SUBJECT: River Bend Station, Unit 1
Docket No. 50-458
Supplement to Amendment Request
License Amendment Request (LAR) 2001-027, Emergency Diesel
Generator Extended Allowed Outage Time, TS 3.8.1.

**Response to Request for Additional Information Related to
License Amendment Request (LAR) 2001-027,
EDG Extended AOT**

**River Bend Plant Cumulative Risk Review
(Nov. 1997 to Dec. 2000)**

RBS Monthly Average CDF Graph (Nov. 1997 ~ Dec. 2000)

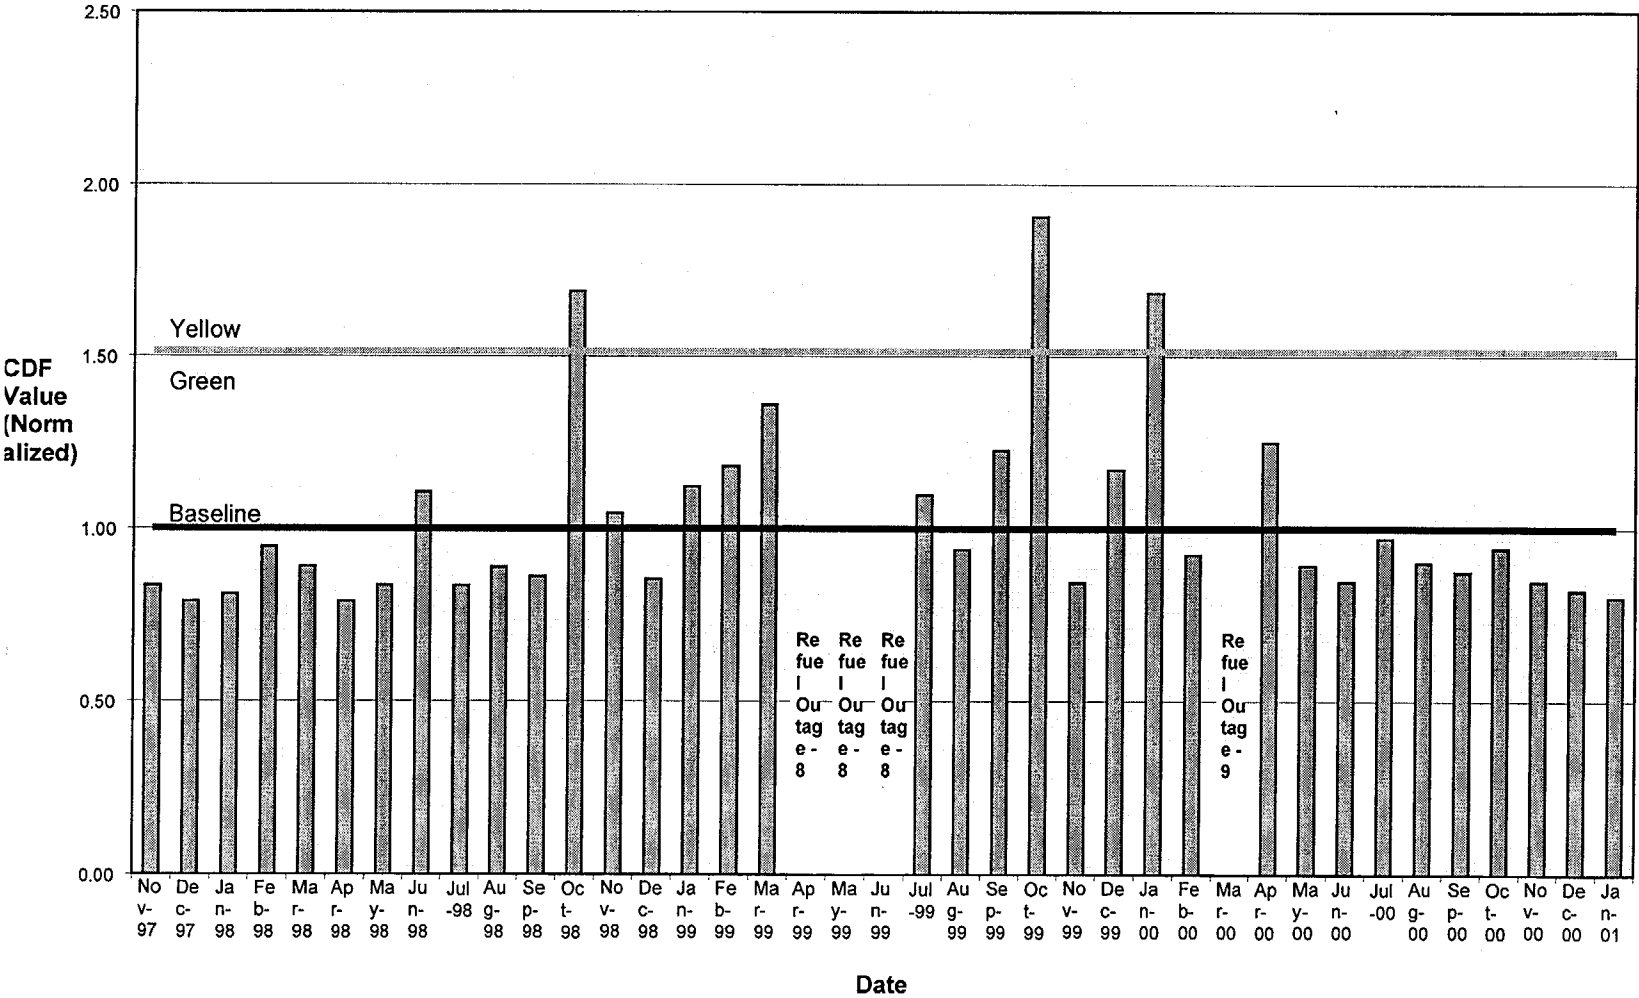
The RBS monthly CDF graph is included as Figure 1. The monthly CDF values were normalized with the RBS Level 1 Rev 3 baseline CDF value. Both baseline CDF and the Green/Yellow transition CDF values are shown on the graph. Note that the CDF values were not calculated during refueling outages. The CDF values should be calculated based on the RBS Level 1 Shutdown EOOS model. For simplicity, these values are not listed here.

The ΔCDF values of all three cases exceed the maximum percent change in permanent CDF considered to be Non-Risk-Significant (32.5% for the baseline CDF value of $9.446\text{E-}6/\text{yr}$ for RBS Level 1 Rev 3 PRA). However, even for the highest CDF change in Oct. 1999, the change in CDP in that month is $(1.801\text{E-}5 - 7.15\text{E-}6)/\text{yr} * 1\text{yr}/12 = 9.05\text{E-}7$, which is acceptable according to the Quantitative Screening Criteria for Temporary Changes based on CDP values in the EPRI PSA Application Guide (TR-105396). Therefore, it is concluded that the risk

Figure 2
1998 Year-to-Date Cumulative CDP

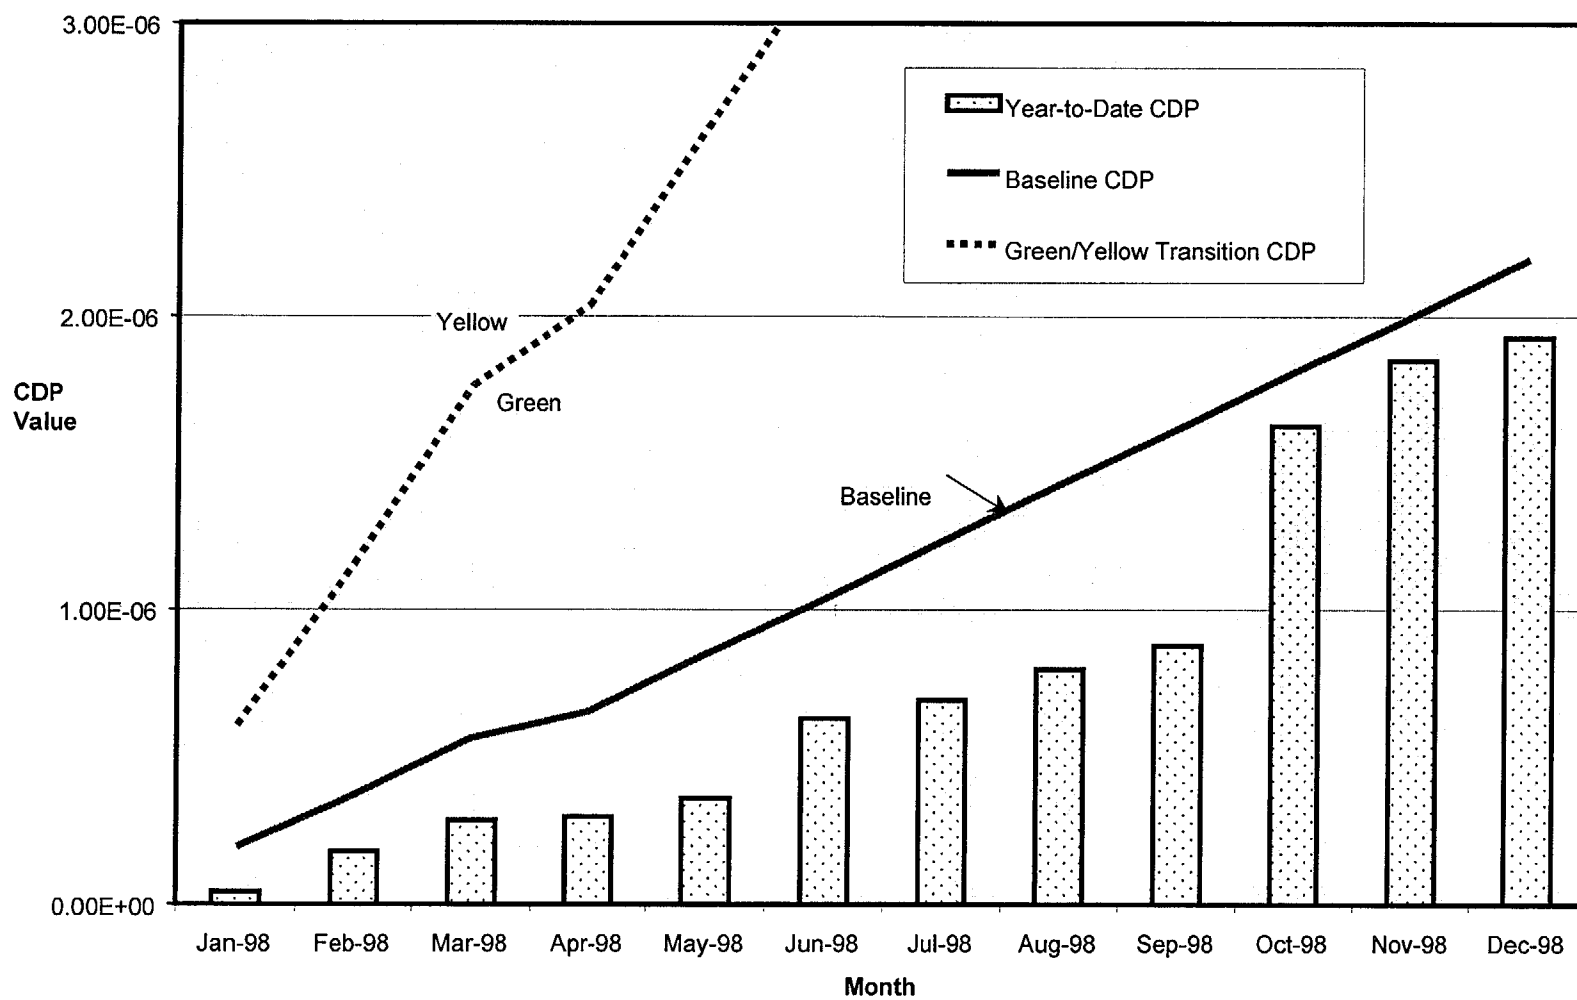
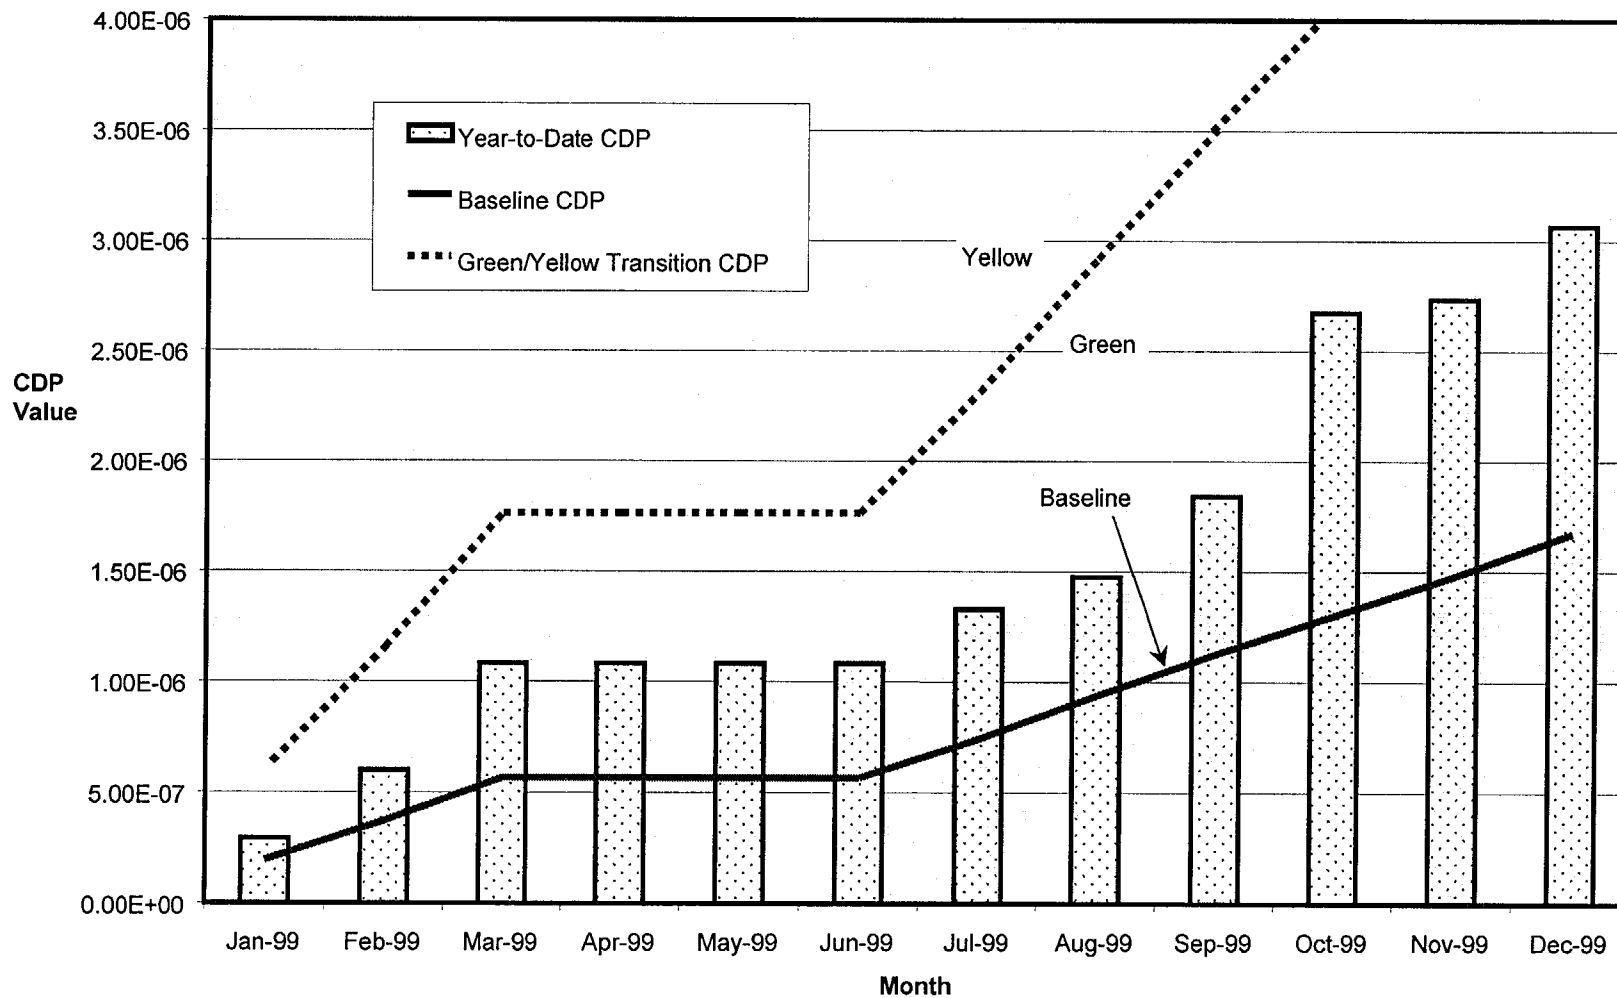
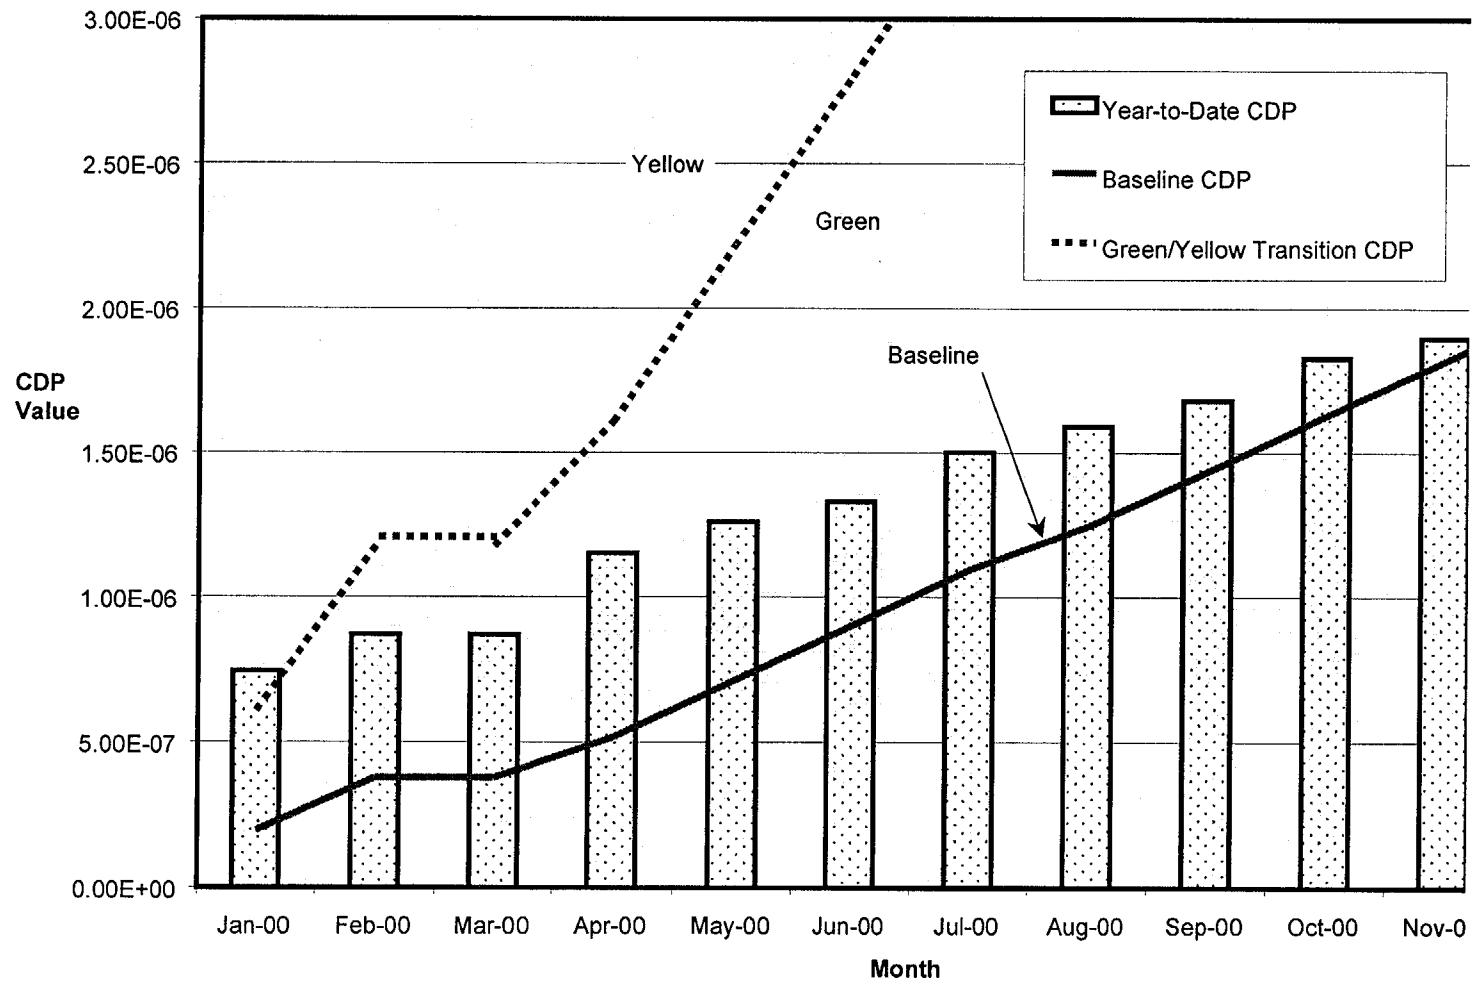
Figure 2 shows the year-to-date cumulative CDP plots for the past three years (1998 to 2000). These figures show the cumulative plant risk over time on a yearly basis and how this relates to the baseline CDP and the CDP values corresponding to the Green/Yellow transition CDF value in EOOS. Since no monthly CDF was calculated for refueling outage months, the cumulative CDP values did not include those months also.

The cumulative risk profile in 1998 shows that the year-to-date CDP values were always below the baseline CDP. And the 1999 cumulative risk profile shows that the year-to-date CDP values were always above the baseline CDP's. However, it should also be noted that the CDP values were still well below the Green/Yellow transition lines. For the 2000 cumulative risk profile, although the figure shows the plant year-to-date CDP values were above the baseline CDP for most of the months, the final CDP value for 2000 was actually lower than the baseline value. It was the higher monthly CDF value in January 2000 that raised the CDP values significantly. As discussed in the previous section based on the monthly averaged CDF values, the risk changes in the past three years were Non-Risk-Significant.
